APPROVED MINUTES

September 16, 2021 Standards Committee Meeting

RE: Minutes from the September 16, 2021 Standards Committee Meeting

E 801-TCFO-01 FLAGGER OPERATIONS (WITH MARKUPS)

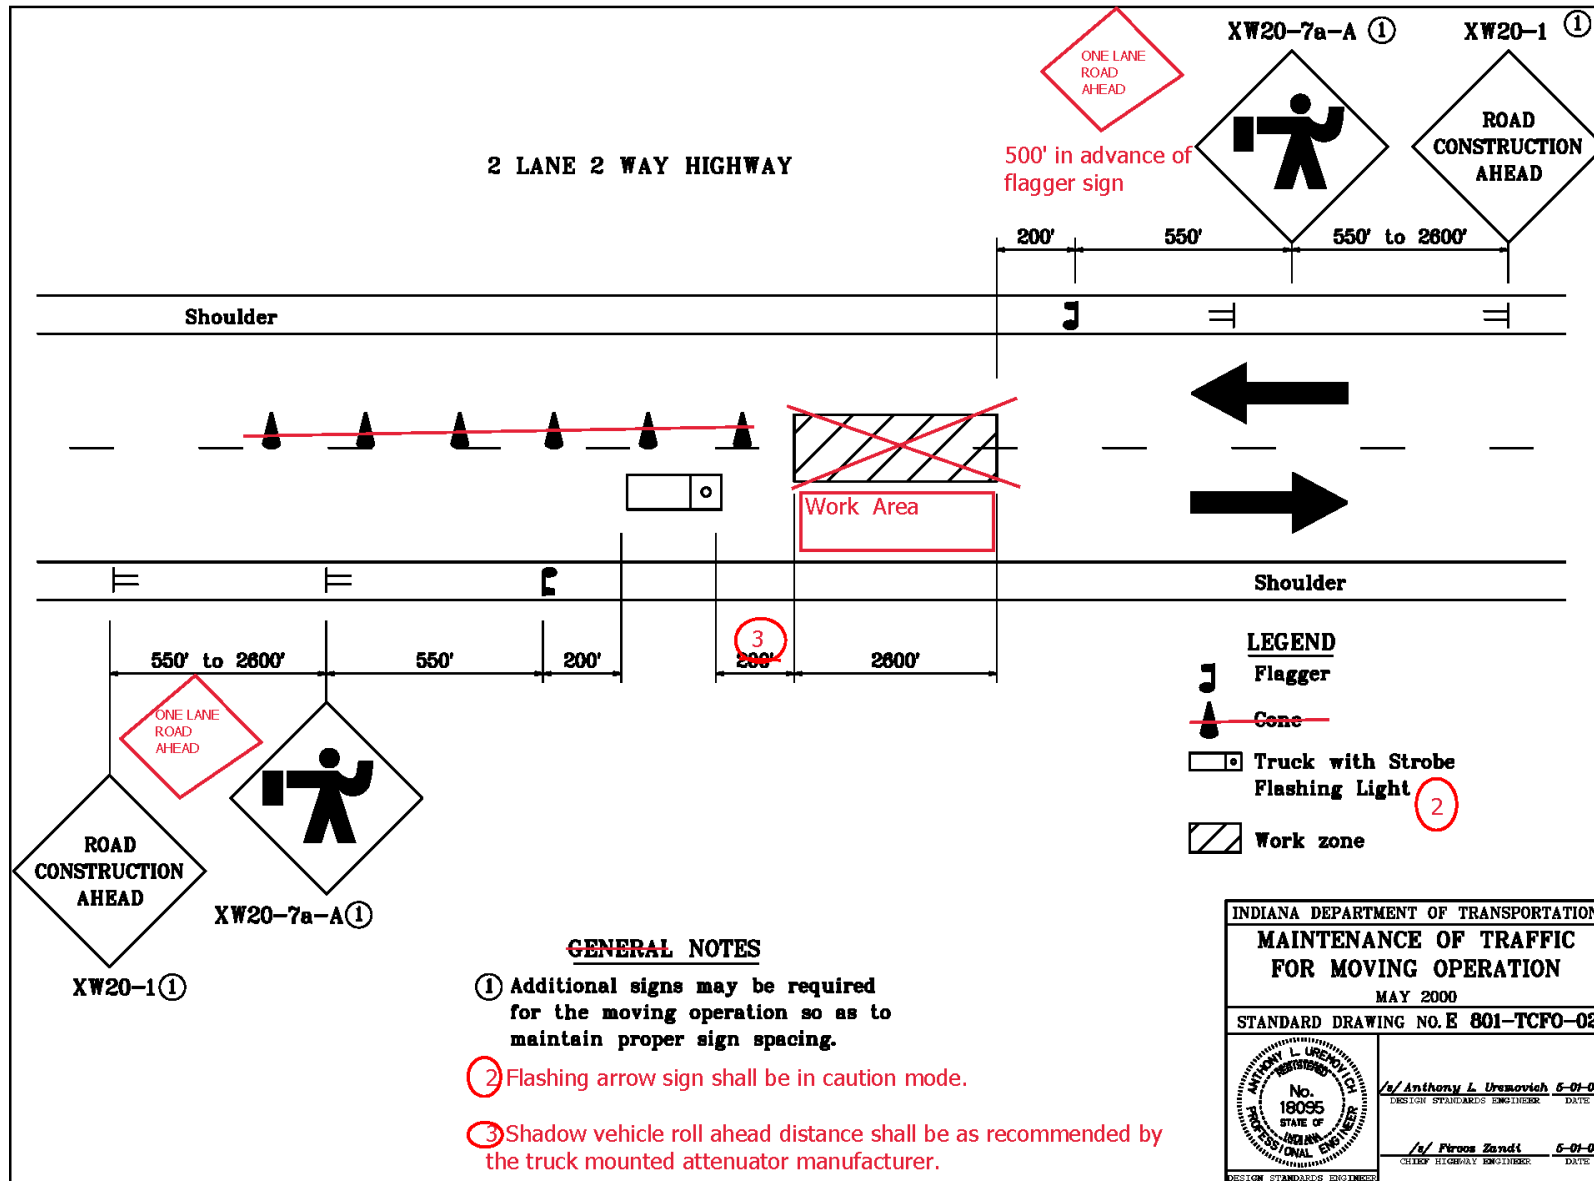
REVISION TO STANDARD DRAWINGS

E 801-TCFO-06 TRAFFIC CONTROL FOR INTERSECTION WORK (WITH MARKUPS)

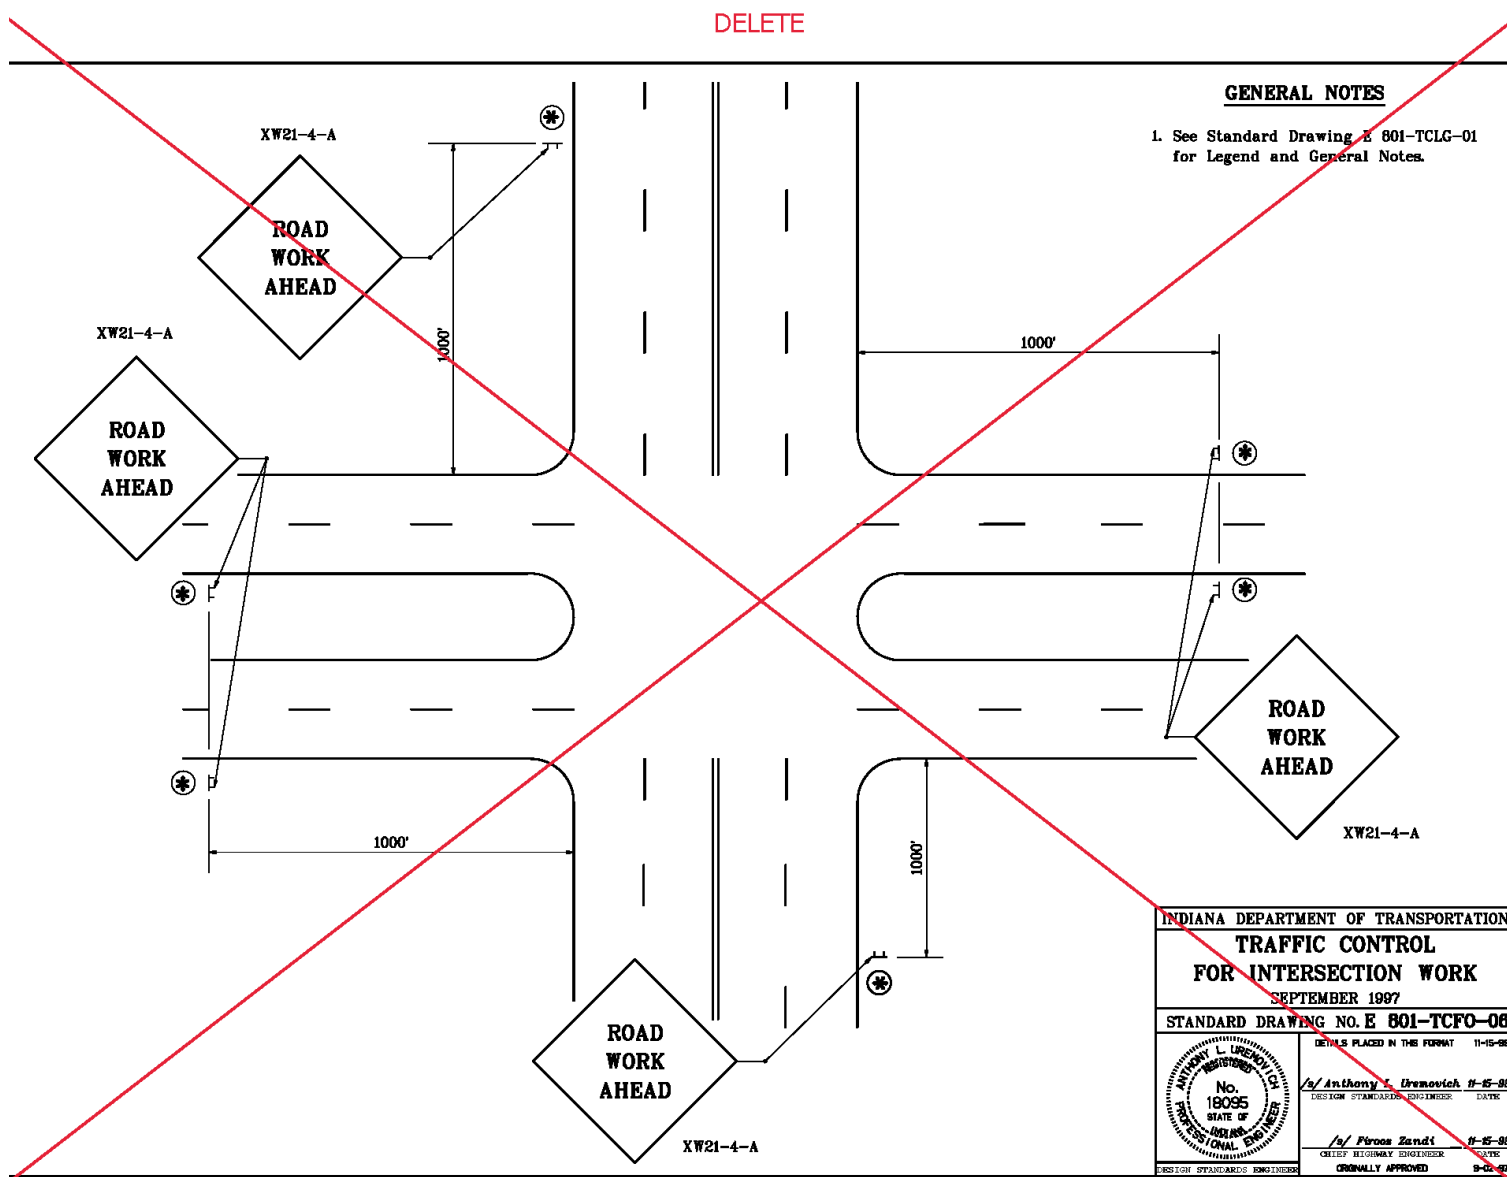
DELETE

E 801-TCTC-05 TRAFFIC CONTROL FOR DAYTIME LANE CLOSURE (WITH MARKUPS)

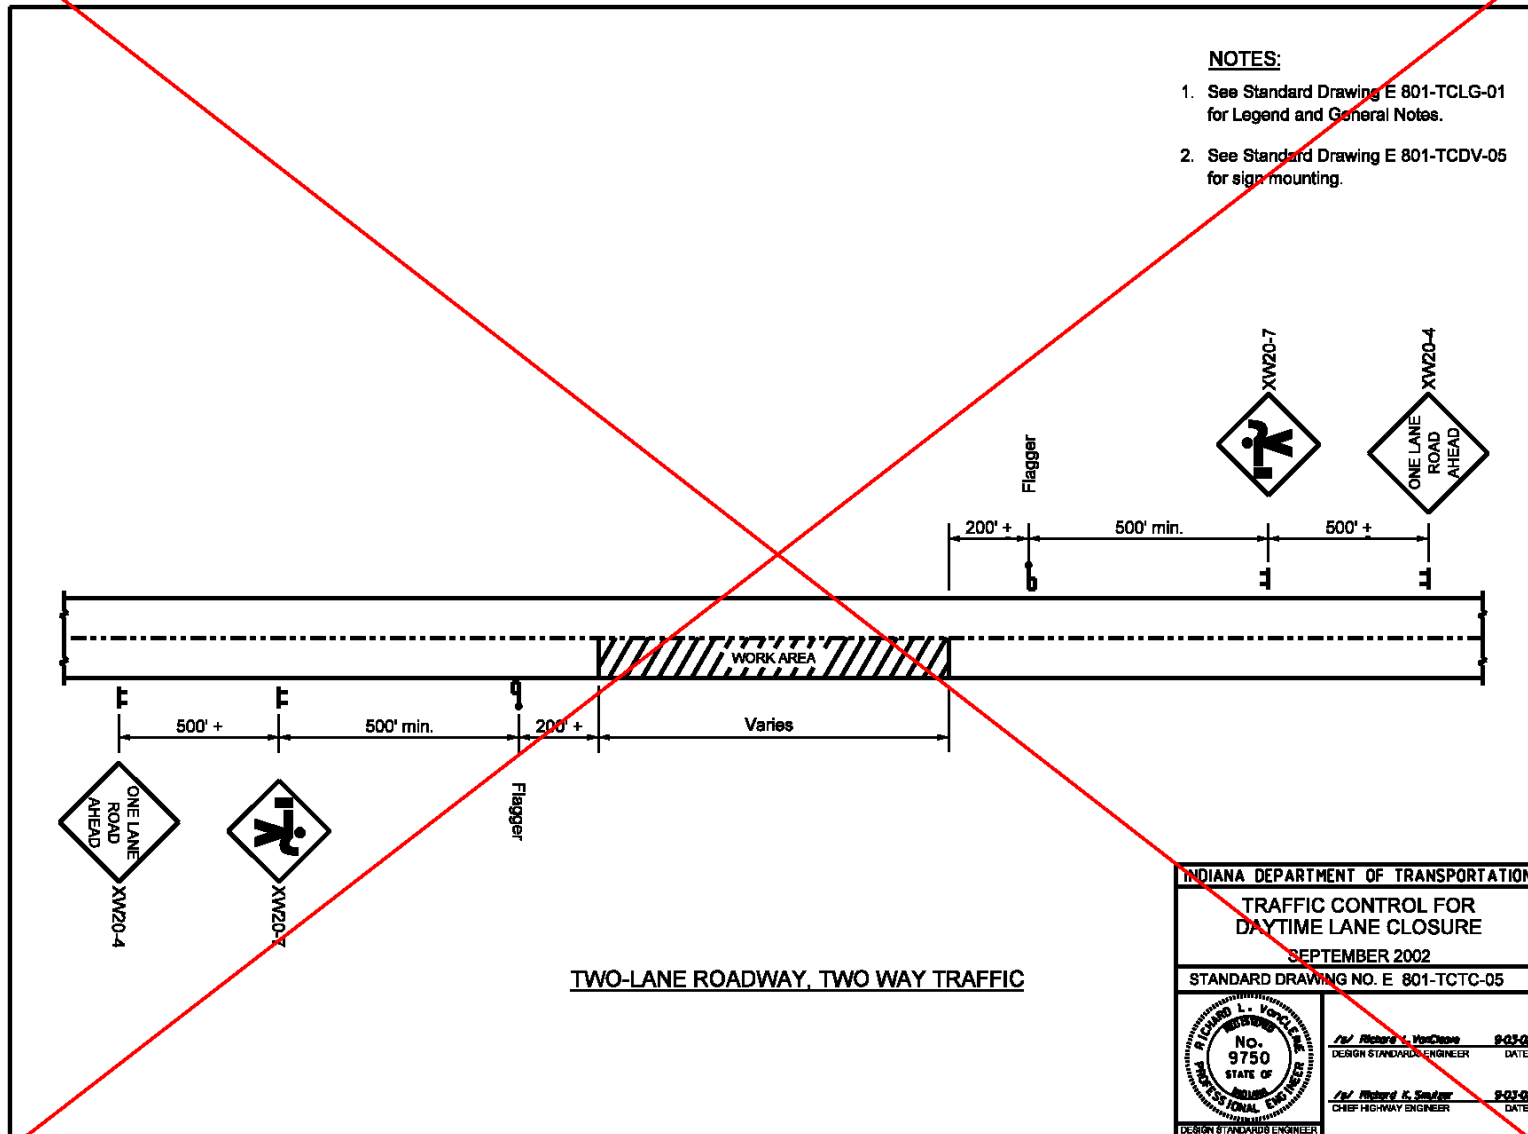
Delete (Addressed in 801-TCFO Series)

E 801-TCTC-06 MAINTENANCE OF TRAFFIC FOR RPM CASTING INSTALLATION (WITH MARKUPS)

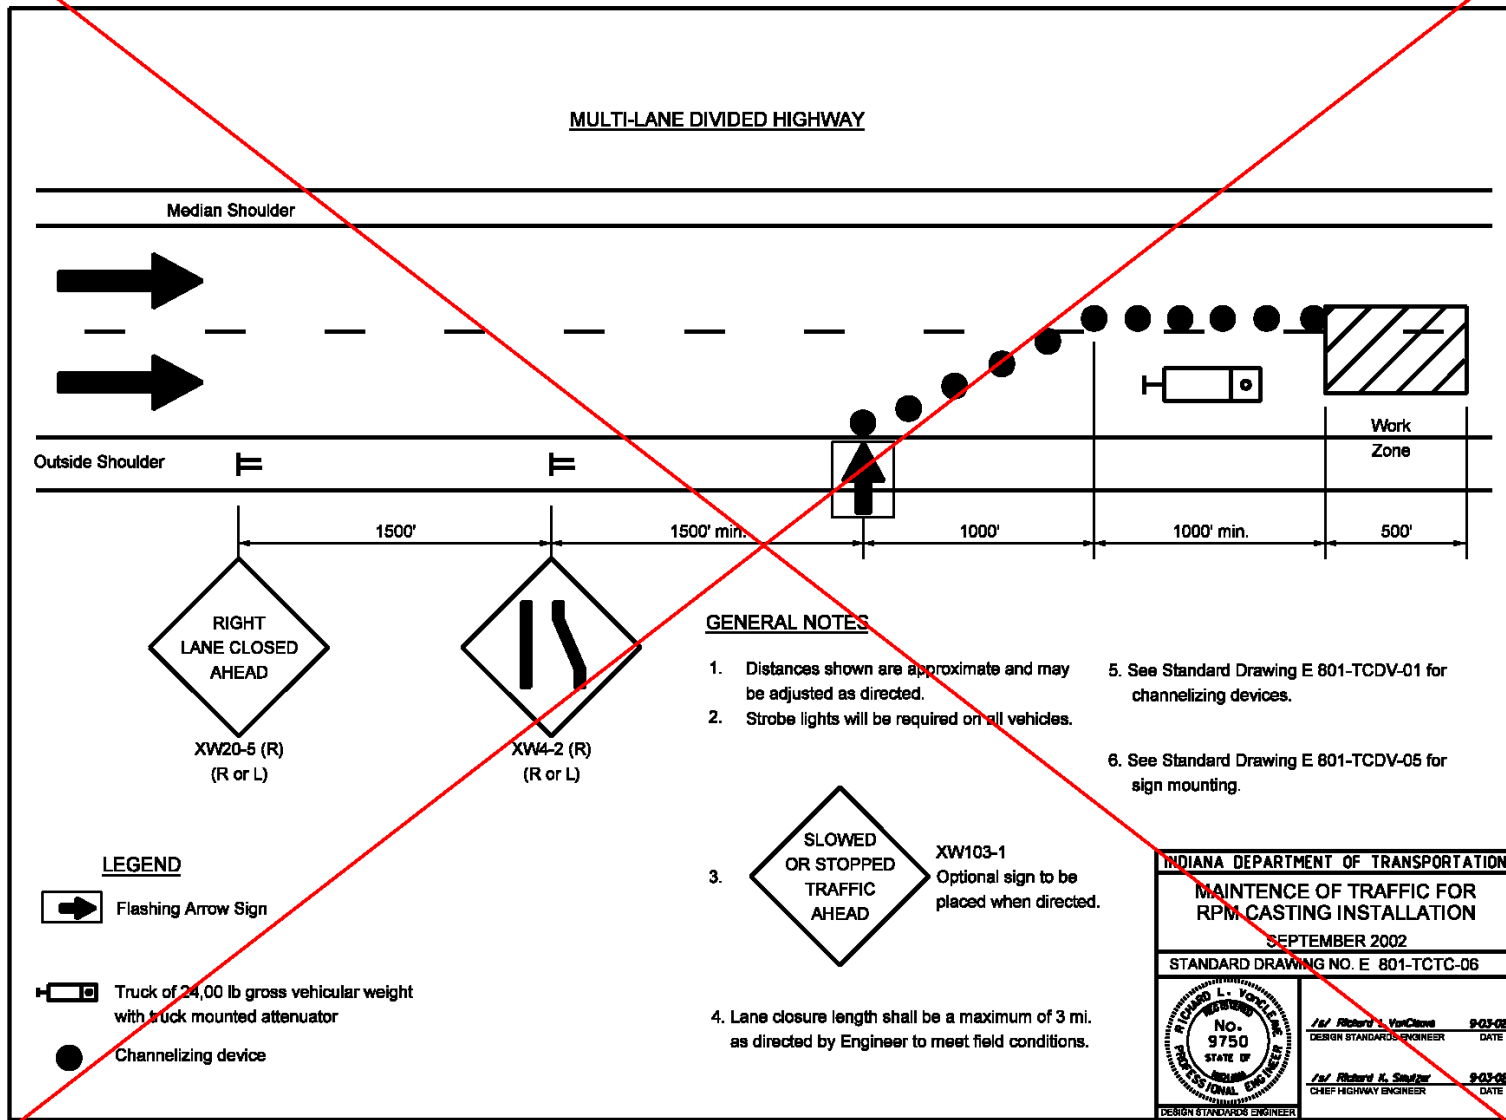
(Duplicate of 801-TCFO-03)

E 801-TCTC-07 MAINTENANCE OF TRAFFIC FOR RPM CASTING REPLACEMENT (WITH MARKUPS)

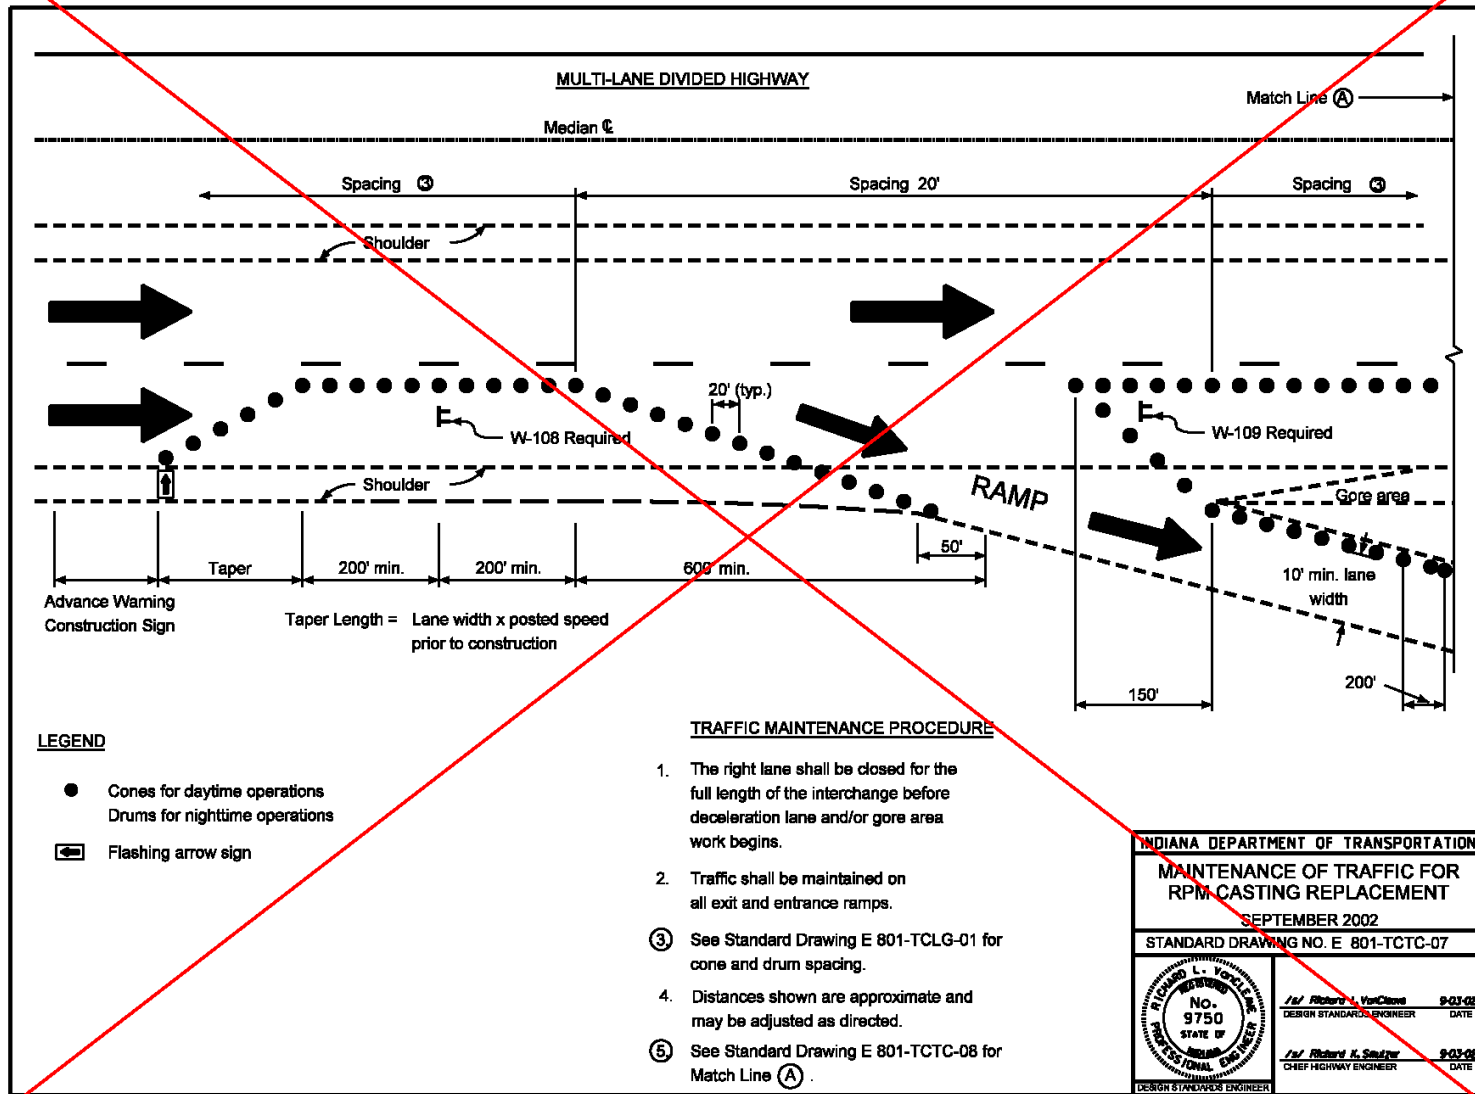
(Addressed in 801-TCLC-15)

E 801-TCTC-09 MAINTENANCE OF TRAFFIC FOR RPM REFLECTOR REPLACEMENT (WITH MARKUPS)

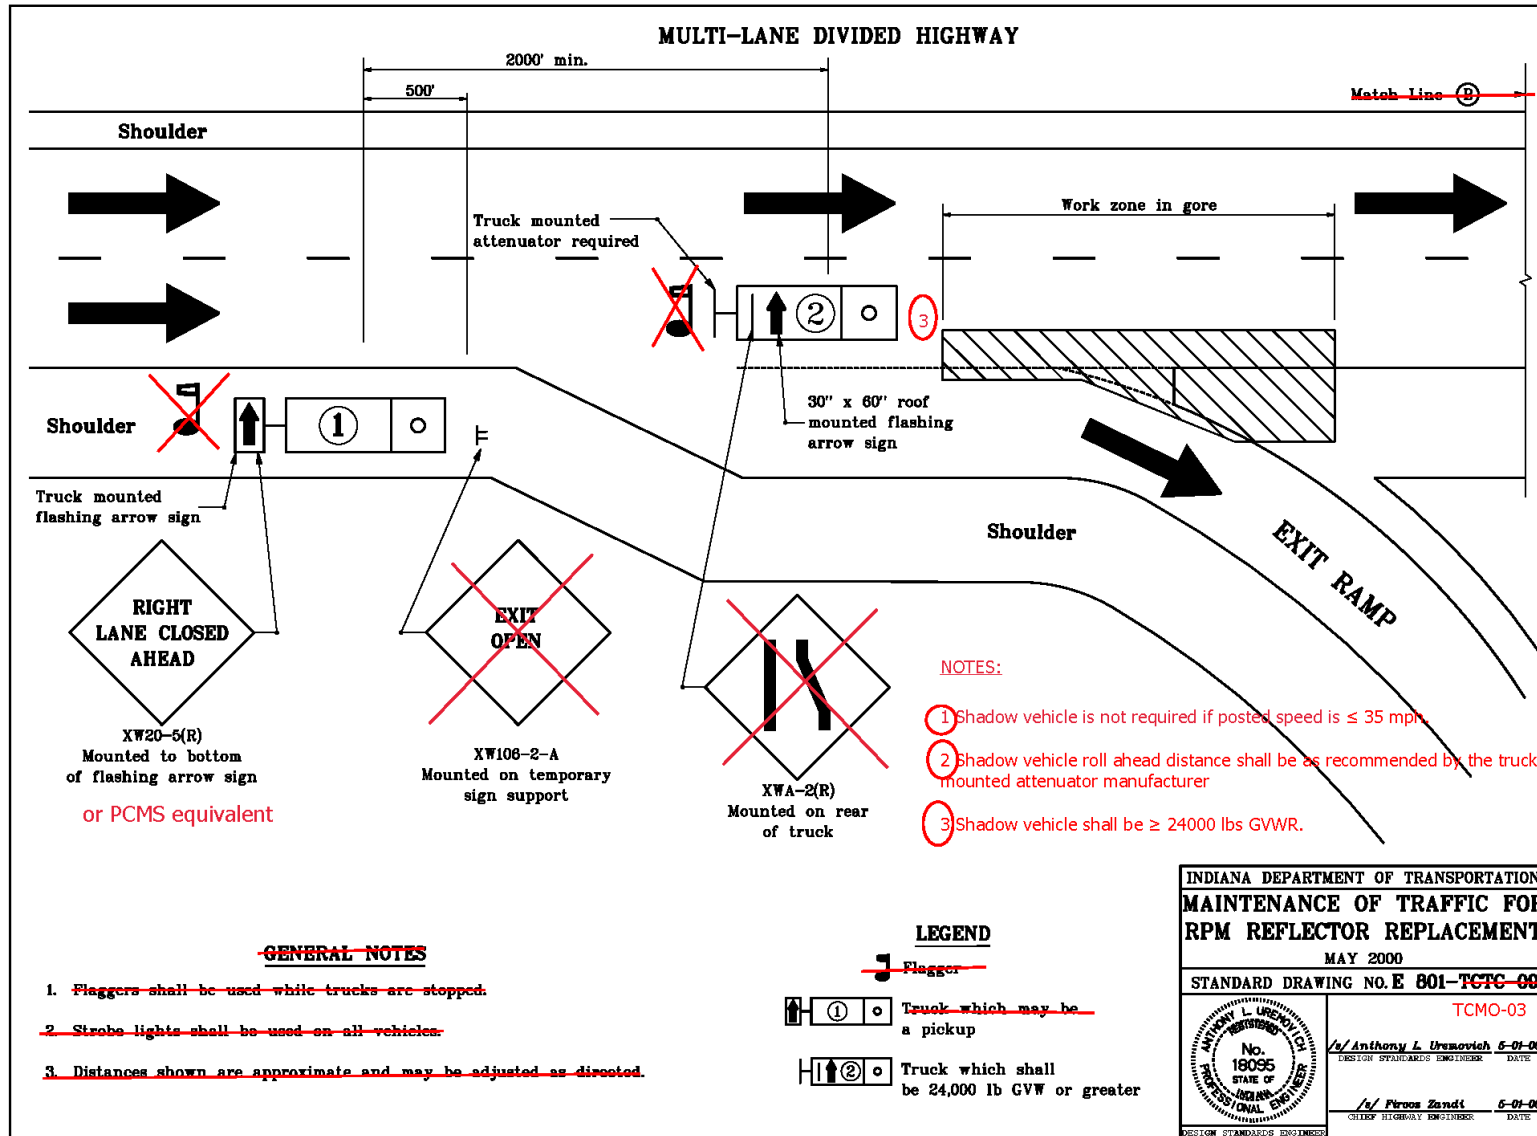
Move to New Series on Traffic Control for Mobile Operations
